## TECHNICAL MEMORANDUM

**Re: RI Phase 3 Modification No. 1  
Results of Well Inspections, Additional Proposed Wells, and  
All Wells Database Update for the Eastside Sub-Area  
Nevada Environmental Response Trust Site  
Henderson, Nevada**

This Technical Memorandum presents Ramboll Environ's recommended Modification No. 1 to the scope of work presented in the *RI/FS Work Plan Addendum: Phase 3 Remedial Investigation, Revision 1* dated October 27, 2017 and approved by NDEP on November 8, 2017 ("Phase 3 RI Work Plan").

Path: \\wceufps\heng\lePetomane\NERT\RI PHASE 3\GIS\Workplan Maps\RI\_Phase3\_Well Inspection Results\_Shallow and New Proposed.mxd

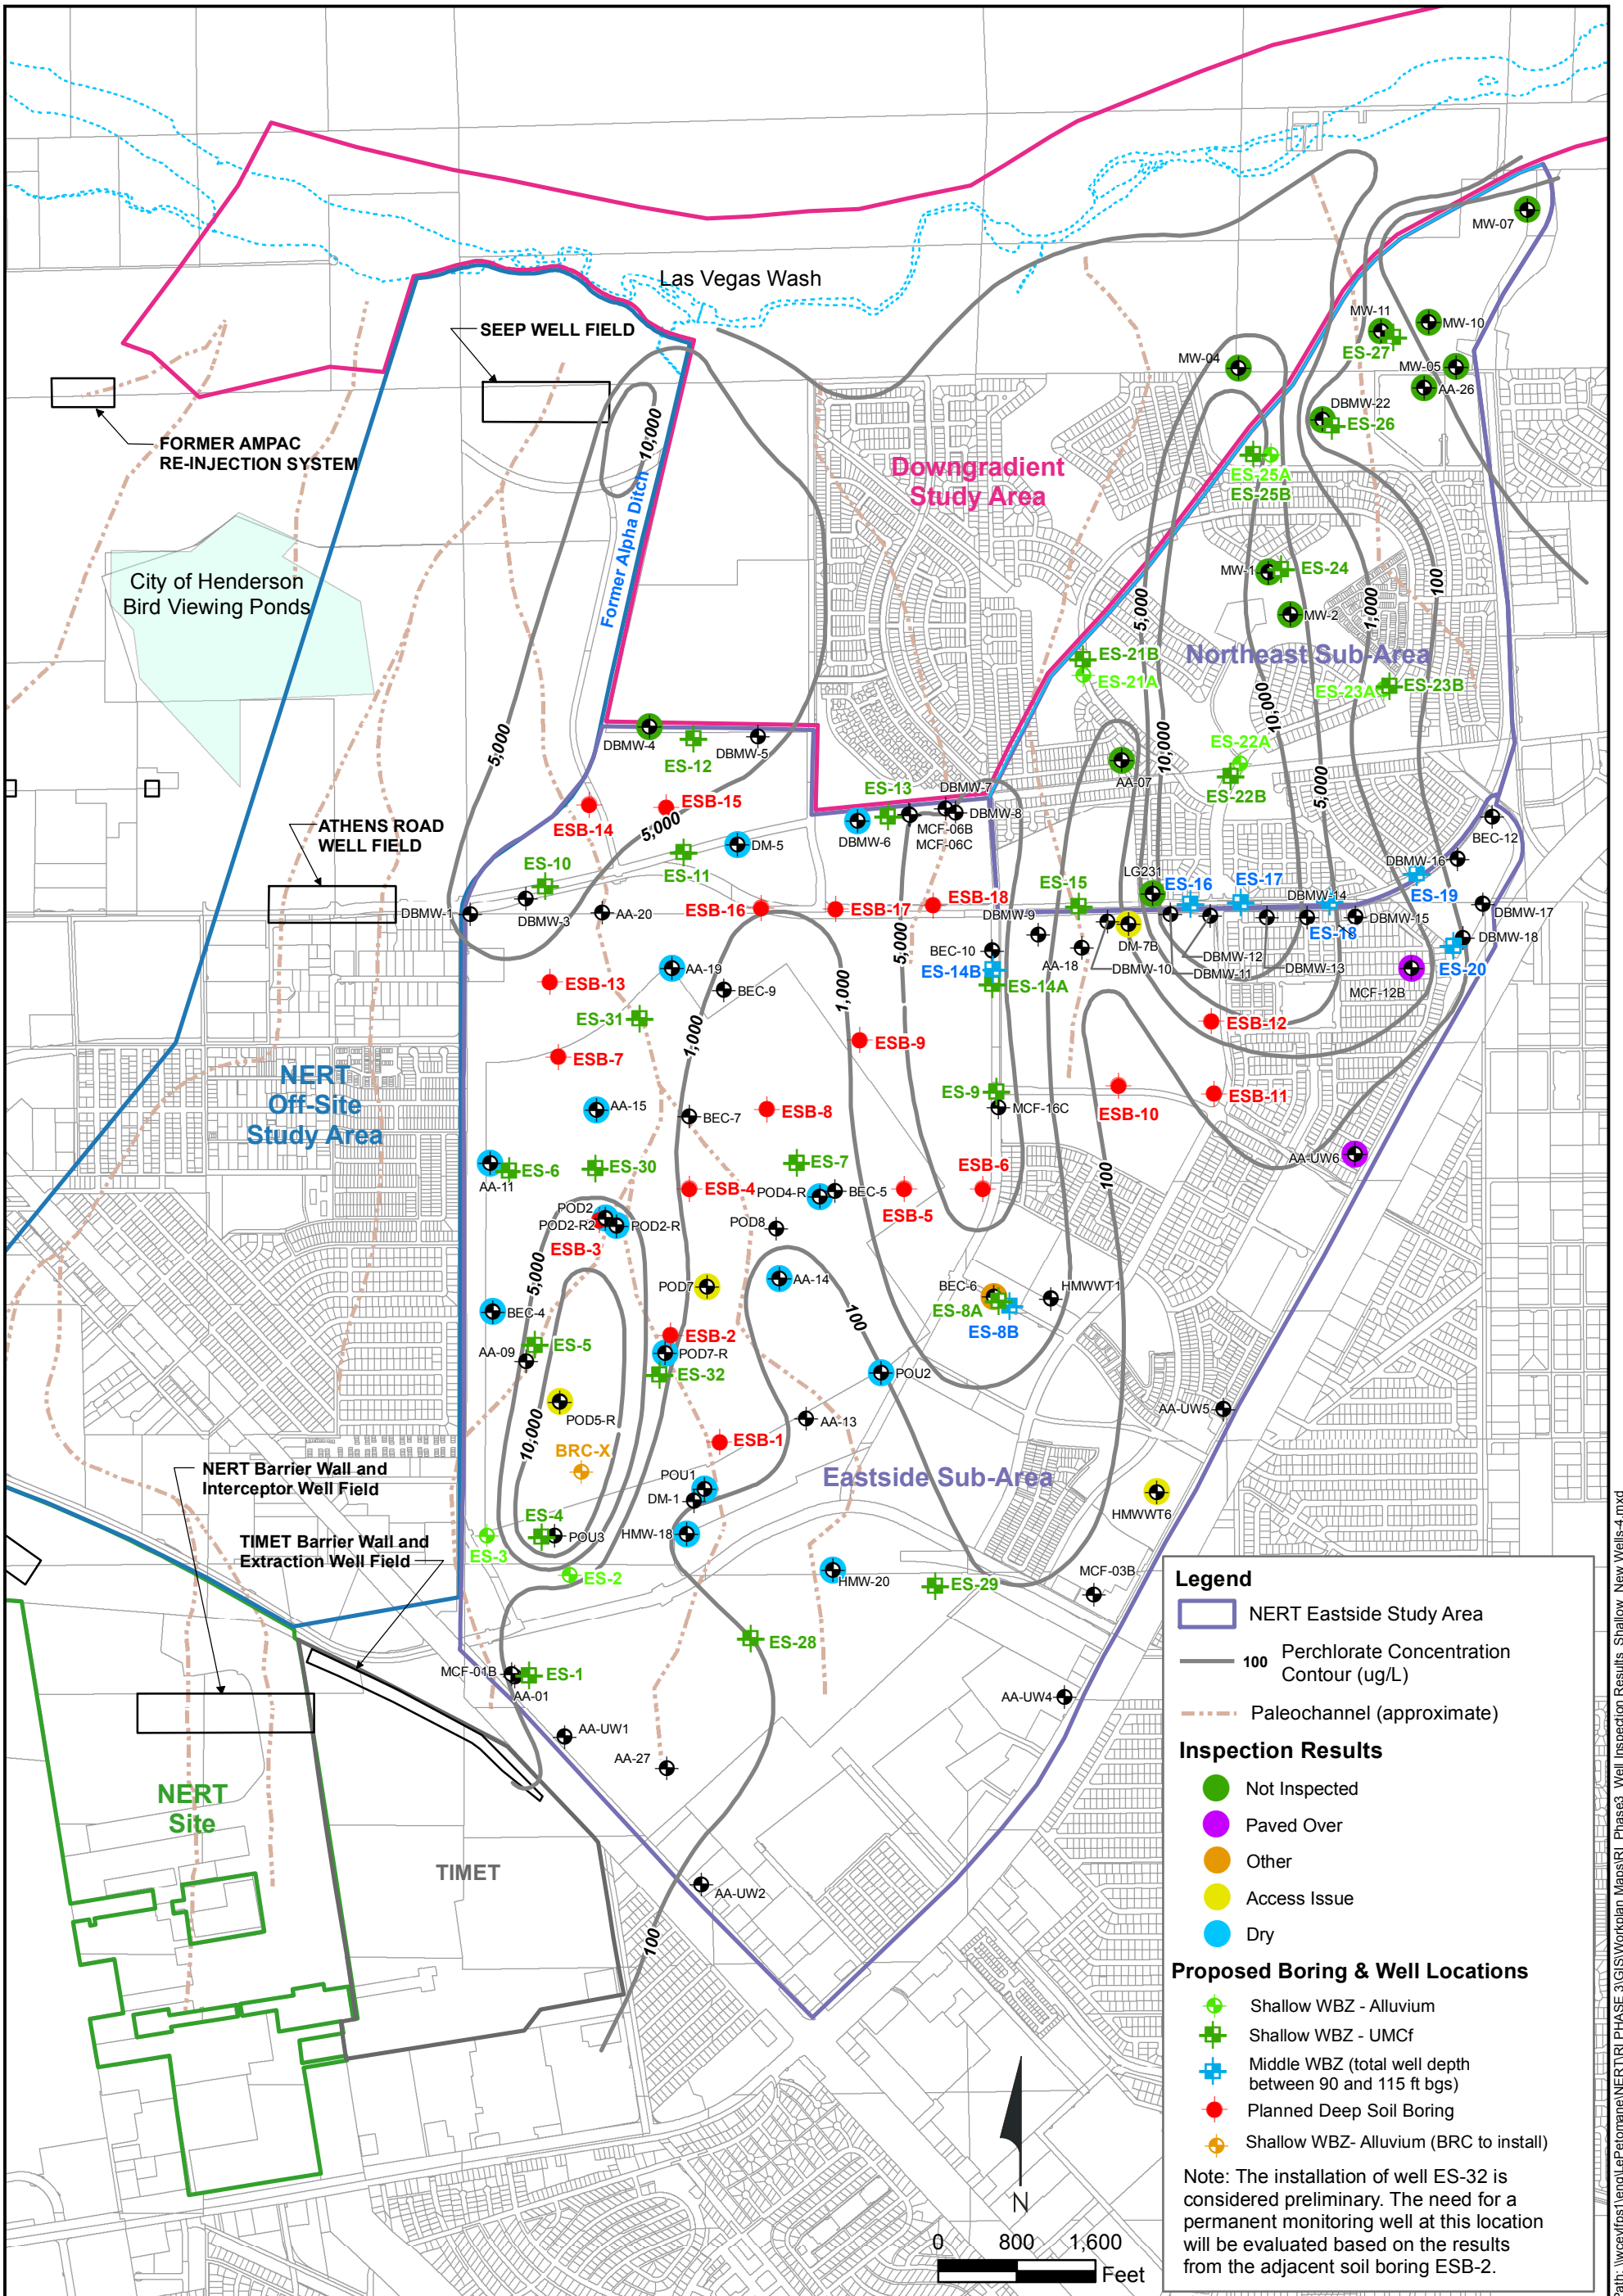
Based on this review, Ramboll Environ recommends adding six (6) wells screened within the Shallow Water Bearing Zone (WBZ) to the scope of the Phase 3 RI Work Plan. Given the lack of recent monitoring data for many wells within the Eastside Study Area, Ramboll Environ anticipated that some well locations identified in the Phase 3 RI Work Plan would likely be damaged or missing. The locations of the proposed new wells are intended to replace missing, dry, or extensively damaged wells considered important to characterizing the distribution of chemicals of potential concern (COPCs) in the Eastside Sub-Area. The addition of these six new wells, combined with the other proposed wells/soil borings and existing accessible well network, will sufficiently characterize COPCs within the Eastside Sub-Area for the purposes of the Phase 3 RI Work Plan. The six proposed additional well locations are shown on Figures 3 and 4.

Proposed Well	Reason for Modification
ES-8A	Serves as a replacement for well BEC-6, which was found to have a substantially different screened interval than reported by the well owner. This location is critical to understanding the extent of higher perchlorate concentrations historically mapped near the center of the Eastside Sub-Area. Proposed well will be screened in the Upper Muddy Creek Formation (UMCf) within the Shallow WBZ.

<b>Proposed Well</b>	<b>Reason for Modification</b>
ES-28	Replaces well HMWWT8 (which could not be located) and provides concentration data in the shallow WBZ within the south-central portion of the Eastside Sub-Area. Proposed well will be screened in the UMCf within the Shallow WBZ.
ES-29	Replaces well HMW-21 (which could not be located) and provides concentration data in the shallow WBZ within the south-central portion of the Eastside Sub-Area. Proposed well will be screened in the UMCf within the Shallow WBZ.
ES-30	Provides data immediately north of an area of historically high perchlorate concentration and serves as a replacement for a number of missing, dry or inaccessible wells. Proposed well will be screened in the UMCf within the Shallow WBZ.
ES-31	Provides data for understanding the distribution of perchlorate in proximity to a mapped paleochannel within the northwest portion of the Eastside Sub-Area and serves as a replacement for a number of dry or inaccessible wells. Proposed well will be screened in the UMCf within the Shallow WBZ.

ES-32	Provides data for understanding the distribution of perchlorate immediately east of a historically high perchlorate concentration area and serves as a replacement for a number of missing, dry, or inaccessible wells. When available, the results from adjacent planned soil boring ESB-2 will be reviewed to confirm the need for a permanent well at this location before well ES-32 is installed. If installed, this proposed well will be screened in the UMCf within the Shallow WBZ.
